REMARKS

Claims 1-13 and 26-30 and 32 are pending. Claims 1-2, 4-5, 8, 12-13, and 26-29 have been amended and claim 31 has been canceled. In the July 12, 2004 Office Action, The Examiner rejected the drawings under 37 CFR 1.83(a), the specification under 37 CFR 1.75(d)(1) and MPEP 608.01(o). Claims 4, 5, and 13 were rejected under 35 U.S.C. 112, first paragraph, and claim 8 was objected to for informalities. Claims 1,2, 6,8, 9, and 26-29 were rejected under 35 U.S.C §102(e) as being anticipated by U.S. Patent Application Publication No. 20030110716 to Hansen ("Hansen"). Claims 1, 7, 8, 11-13, 26, and 30-32 were rejected under 35 U.S.C. §103(a) as being unpatentable over U.S. Patent No. 4,844,420 to Ouster ("Ouster") in view of Hansen. This rejections and objection are respectfully traversed.

IN THE DRAWINGS

FIGURE 2A

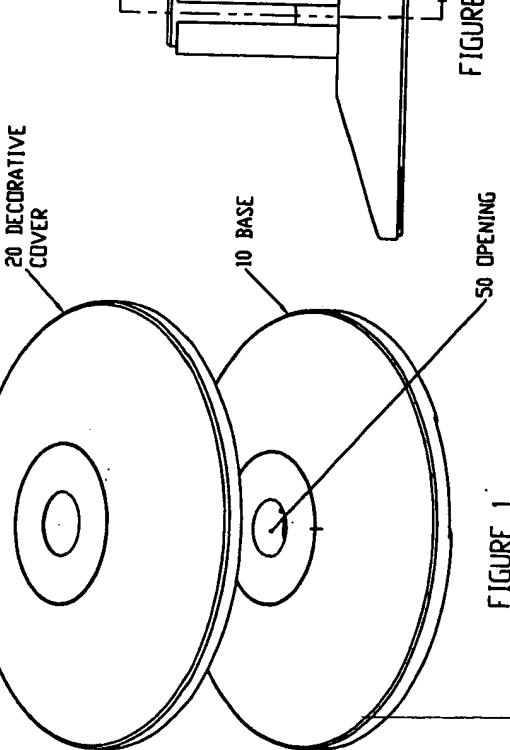
The Examiner also requested that the drawings show a [permanent connection]. The Examiner is respectfully requested to note that Figure 2A is a drawing that we would use to show a an embodiment where the lower portion is "permanently connected" to the base. Additionally, the Applicants respectfully state that 1) a permanent connection, such as one could be drawn, is not claimed. Only that the lower portion is permanently connected to the base is claimed, and such a permanent connection could be performed in a myriad of ways such as the use of Locktite to seal an insert in a threaded chamber or machining the base and the lower portion together. The subject matter sought to be patented in the corresponding claim would cover any and all of the possible ways of permanently connecting the lower portion to the base; 2) The code of 37 CFR 1.81 (a) states only that applicant "is required to furnish a drawing of his or her invention where necessary for the understanding of the subject matter sought to be patented." Applicants respectfully submit that a drawing of the base being permanently connected to the lower portion is not required to understand the subject
